JTB00619NAS1

TECHNICAL BULLETIN

Hood Open Warning Displayed On The Instrument Cluster

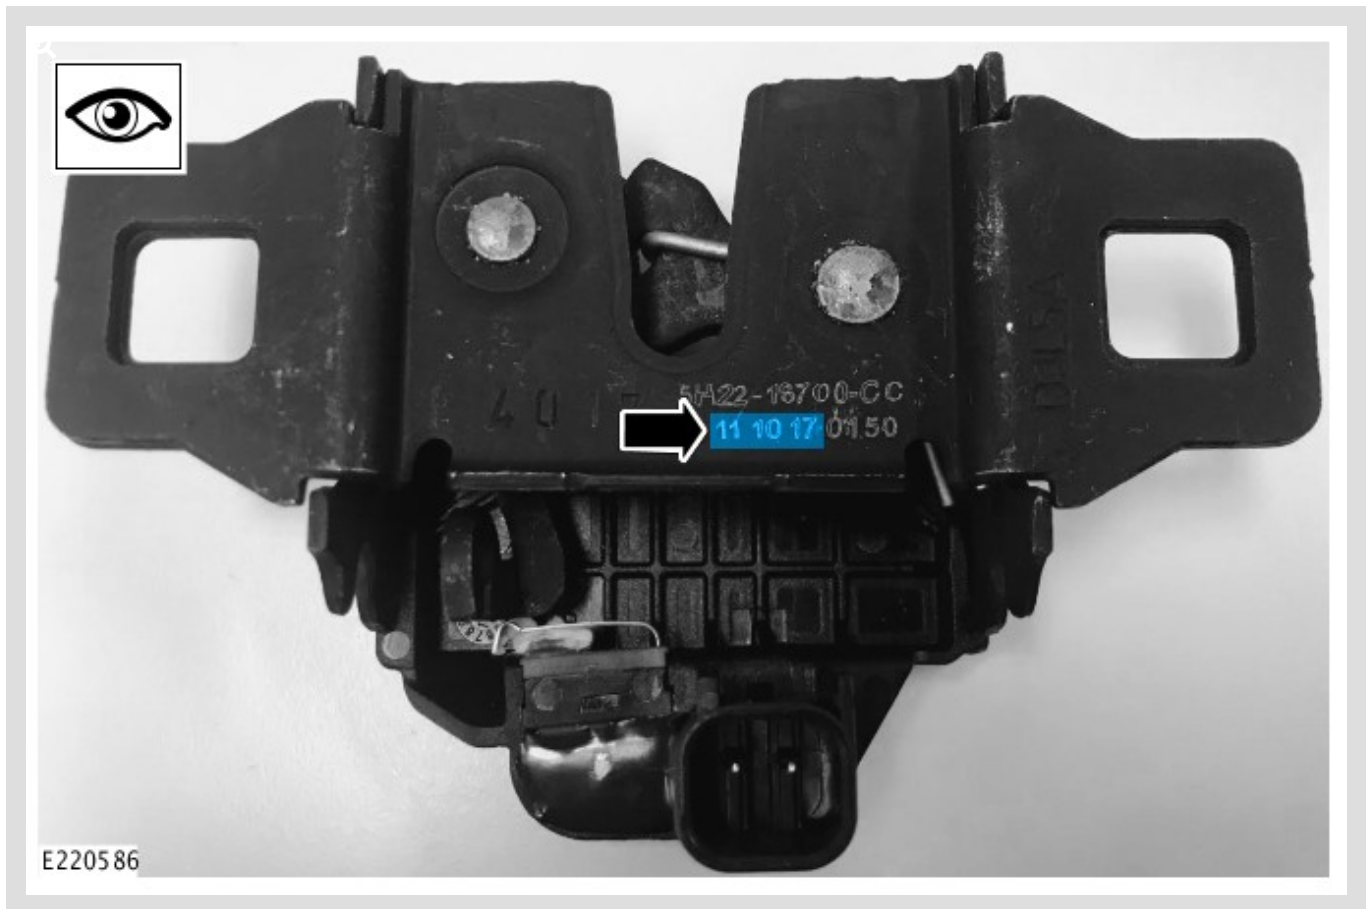
Date shown: 11/10/17 (11 October 2017).

The date code (DD/MM/YY) of the new hood latch must be **23/11/2017 (23 November 2017)** or later.
